Purchase College RFP SU-060815  
Solar Power Purchase Power Agreement

**Addendum #02-Consultant's Questions & Answers**

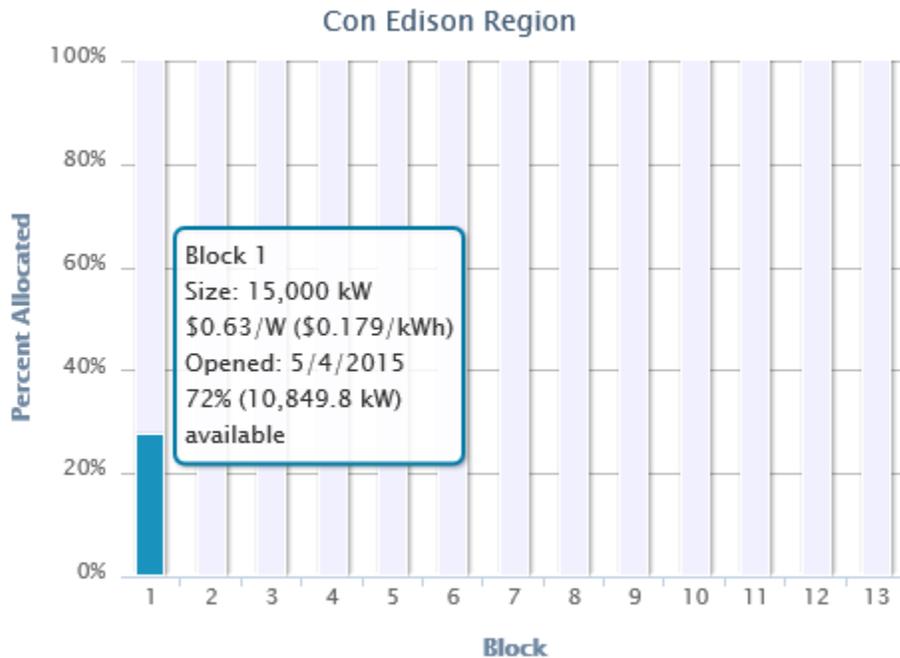
Q15. Please provide the main switchgear information for each building including Amperage and Voltage.

**A15. See addendum #08 for KVA and voltage information.**

**The Consolidated Edison Company supplies underground electric service at the south property line, which is located at the intersection of Lincoln Avenue and Anderson Hill Road. Two (2) Con Edison 13,200 volts, three-phase grounded neutral, 60 Hertz feeders extend from the property line north along Lincoln Avenue to the main campus switchgear. These feeders are metered in the Mechanical Services Building. The two (2) Con Edison feeders each supply one (1) section of a three (3) section 13 KV distribution switchgear. The sections are connected together through one**

normally open and one normally closed tie breaker. In the event of a prolonged outage of either incoming feeder, the open tie will close and all distribution sections can be carried on one feeder. The campus distribution system consists of five (5) dual radial 13.2 kV feeders originating at the Mechanical Services Building and distributed to building substations in a system of underground duct banks and manholes. Each campus distribution feeder is connected to separate sections of the campus switchgear. The primary feeder selection is made at the individual building substations.

The cable used in the electric service and distribution system is rated for 15 KV, three (3) phase, 60 Hertz, grounded neutral service. All main primary switchgear is rated at 1000 MVA and each of the incoming feeders has a capacity of approximately 12 MVA. In addition, each of the campus distribution feeders has a capacity of approximately 6.2 MVA. The primary switchgear is rated 1000 MVA, 15 KV and the primary of building transformers is 13,200 volts three (3) phased delta. The campus has underground duct banks, which are constructed of asbestos cement conduits encased in a reinforced concrete envelope. The manholes are precast concrete with a cast iron frame and cover.
